15151-15155 W. Mission Hills Road
DOT Case No. SFV21-52493

Subject: **UPDATED TRANSPORTATION ASSESSMENT FOR THE PROPOSED EXPANSION OF ARARAT HOMES DEVELOPMENT LOCATED AT 15151-15155 WEST MISSION HILLS ROAD (ZA-2021-832-ELD-ZAA-ZAD-SPR/ENV-2021-833-EAF)**

A1.00

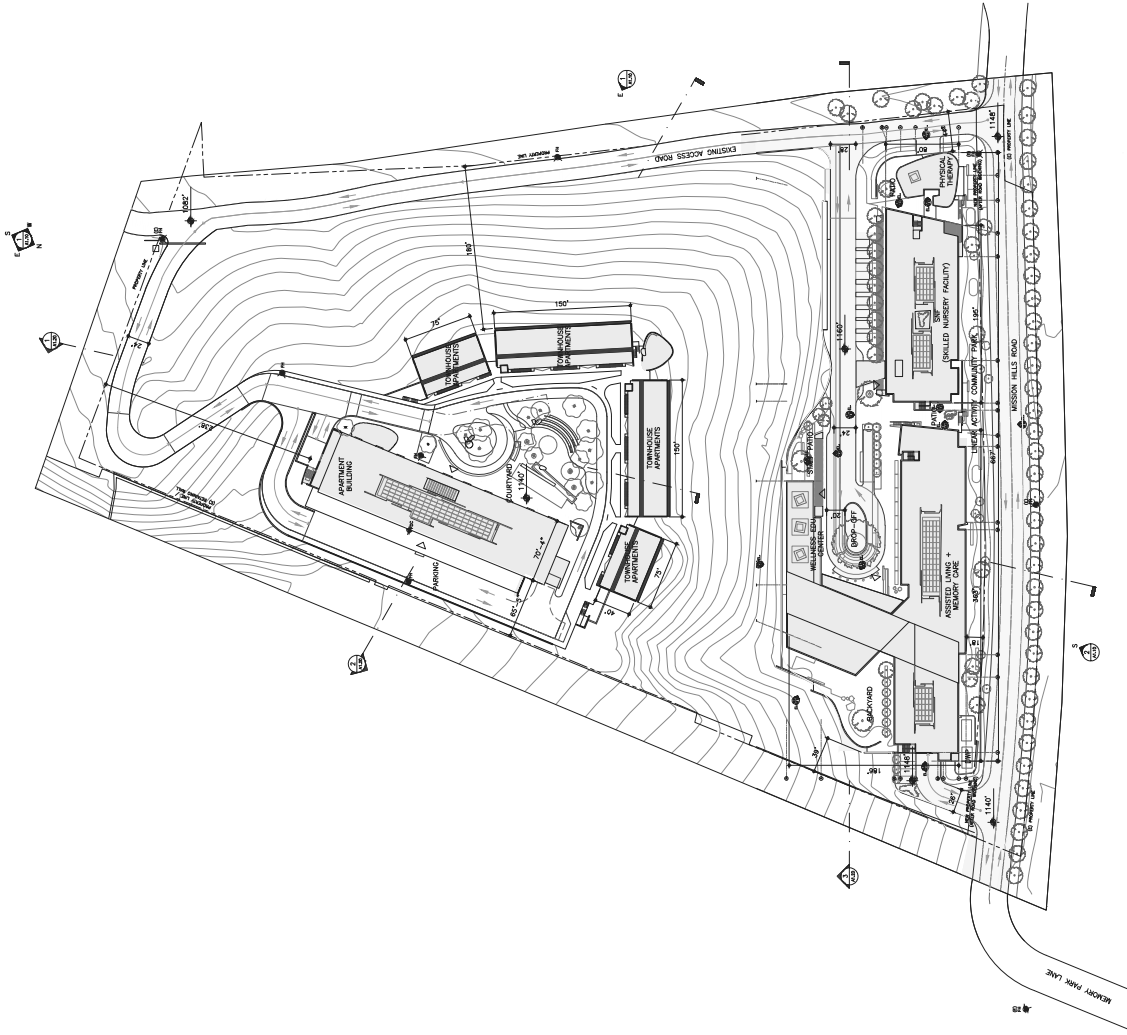
Vehicular access to the proposed development will be provided via a driveway on Mission Hills Road at the western boundary of the Project site and via the existing local access road along the eastern boundary of the site. The Mission Hills Road driveway will provide both ingress to and egress from the parking structure underneath the proposed assisted living and nursing home. The access road driveway will provide access to the proposed senior adult housing development to the north as well as the pick-up/drop-off area for the proposed assisted living and nursing home facilities as illustrated in **Attachment C**. The review of this study does not constitute approval of the dimensions for any new proposed driveway. Review and approval of the driveways should be coordinated with LADOT's Citywide Planning Coordination Section (6262 Van Nuys Boulevard, 3rd Floor, Room 320, at 818-374-4699). In order to minimize and prevent last minute building design changes, the applicant should contact LADOT for driveway width and internal circulation requirements prior to the commencement of building or parking layout design. The applicant should check with City Planning regarding the Project's vehicular access and design.
